ROBUST S5 STATOR VANE FOR THE 6F/7F/9F GAS TURBINES FLARED COMPRESSORS

Applicable to F-Class Flared .03 and .04 Compressors

Robust S5

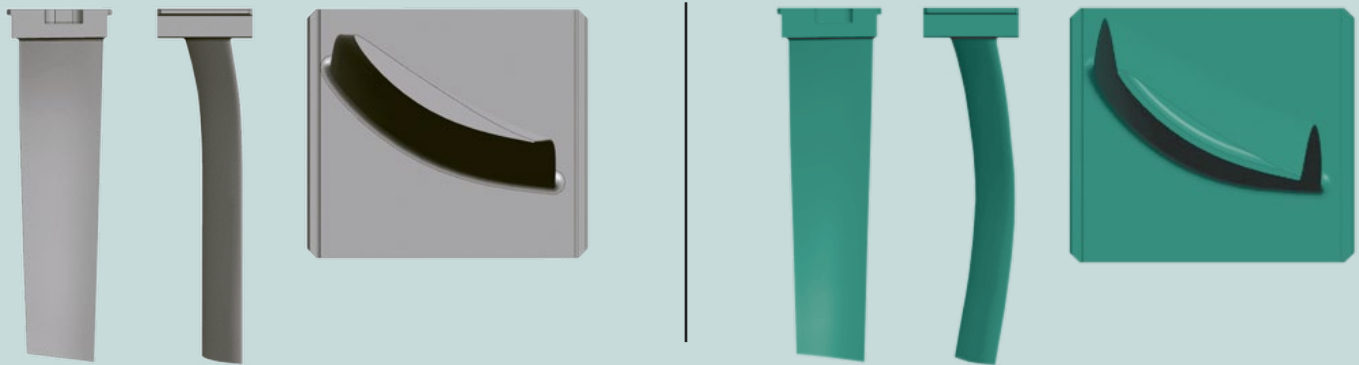
The S5 vane for flared F-class compressors has been redesigned to increase robustness. The design was fully validated via instrumented unit test. The robust S5 builds upon the enhanced S5 as it also incorporates the vane base load dams. The robust S5 will be incorporated into Enhanced Compressor Packages 2+, 3, 4, and 5 in 2020 (6F/7F) and early 2021 (9F). The robust S5 will only be available as a full stage S5 replacement option for existing enhanced compressor installations.

Airfoil modified to provide additional robustness

- Improved damage tolerance to corrosion pits/foreign object damage/rubs/compressor surge
- Squealer tip provides improved rub tolerance
- Ideal for units operating in corrosive environments.
